# Amphenol Communications Solutions

## Production/Engineering Change Notice

Code: ECN20230605-02

Customer :		AICE		Issue Date:		2023.Jun.05	
P/N:		MF30-HM1T		Description		Male Terminal for MF30 Housing Tinned Reel	
Items for change:			The mold is replaced by a new one.				
Reasons for change:			The old mold is EOL. We have to open a new one for production.				
Before Change				After Change			
Drawing No.		MF30-HM1T		Drawing No.		MF30-HM1T	
Rev.	A	Issue date:	2009.Mar.17	Rev.	B	Issue date:	2023.Jun.05
<div>1.</div> <div>Top view</div> <div></div> <div>Side view</div> <div></div> <div></div> <div>Front view</div> <div></div> <div>2. Section view:</div> <div></div>				<div>1.</div> <div>Top view</div> <div></div> <div>Side view</div> <div></div> <div></div> <div>Front view</div> <div></div> <div>2. Section view: Passed</div> <div></div>

### 1.Retention Force for MF30-HM1T

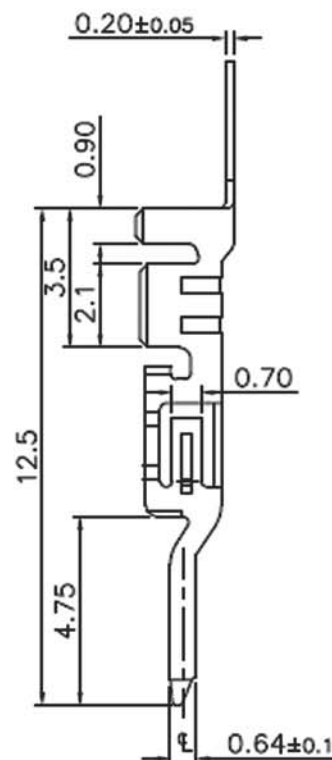
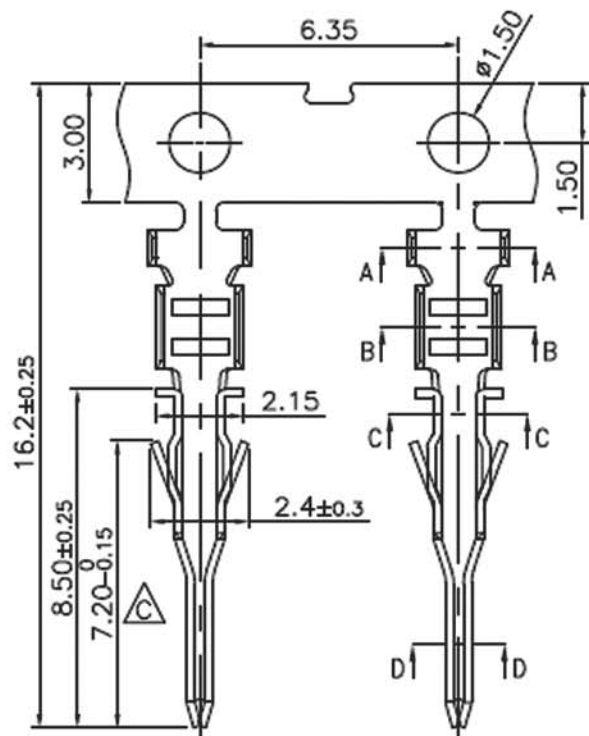
## Test Result

PN \ Sample#	Sample#			Judge
	#1	#2	#3	
MF30-HM1T	4.391 kgf	4.421 kgf	4.384 kgf	Pass

### 3. Test summary : PASS
